ADDENDUM NUMBER 4  
for  
ADVANCED TREATMENT PROJECT  
FORT THOMAS TREATMENT PLANT  
NORTHERN KENTUCKY WATER DISTRICT

FROM: CH2M HILL  
TO: Plan Holders of Record

AS SHOWN	
VERIFY SCALE	
BAR IS ONE INCH ON ORIGINAL DRAWING.	
DATE	CDD-DATE
PROJ	380723
DWG	FT-D-505
SHEET	131

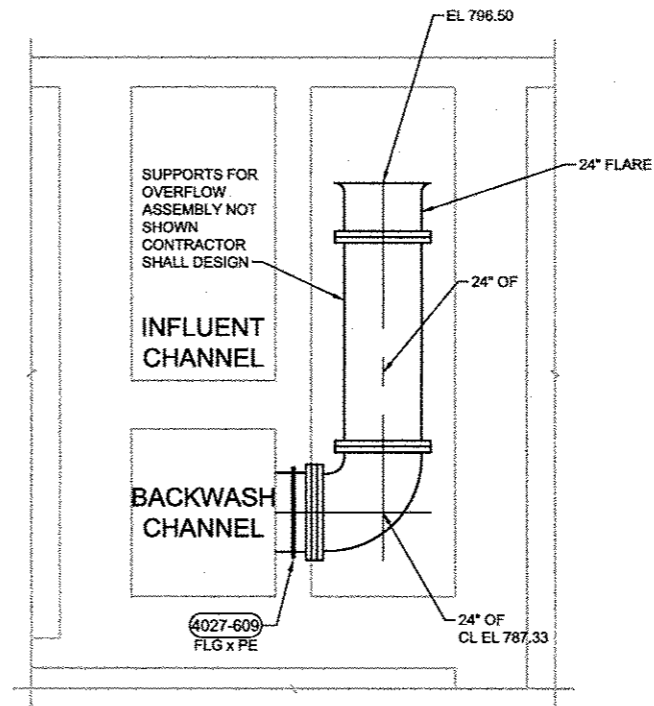
Replace this sheet with the attached FT-D-505.
